## Engineering Change Notification

Reference number: R&D/CCD/Ecn-04/07  
Date/Issue: April 2007 Issue 1  
Part: Z-Hub/9

## 2. Increased coupling diameter between hub and retainer

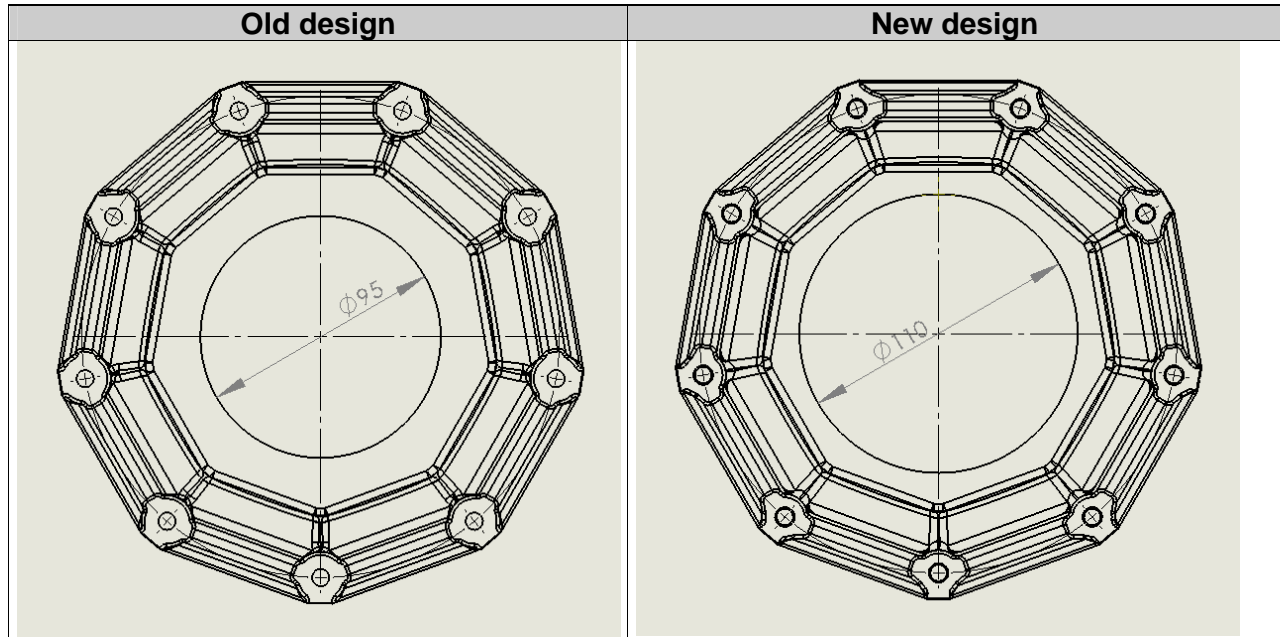
To increase the free area for machining of mounting holes the coupling diameter is changed from  $\text{Ø}95\text{mm}$  to  $\text{Ø}110\text{mm}$ , which is the maximum possible with the current mould design.

### 3. Z-Retaining Plate/9/000090

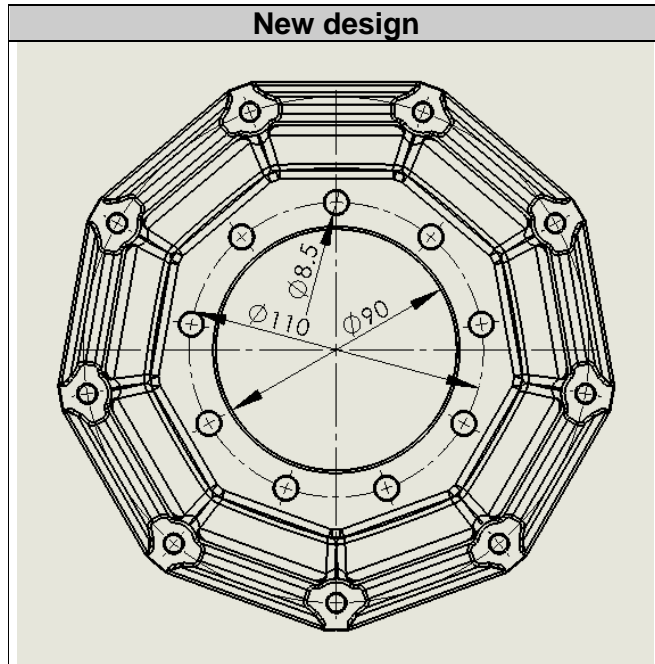
The parts Z-Hub Plate/9/90/9x8,5/BC110 and Z-Retaining Plate/9/9x8,5/BC110 will be replaced by Z-Retaining Plate/9/000090.
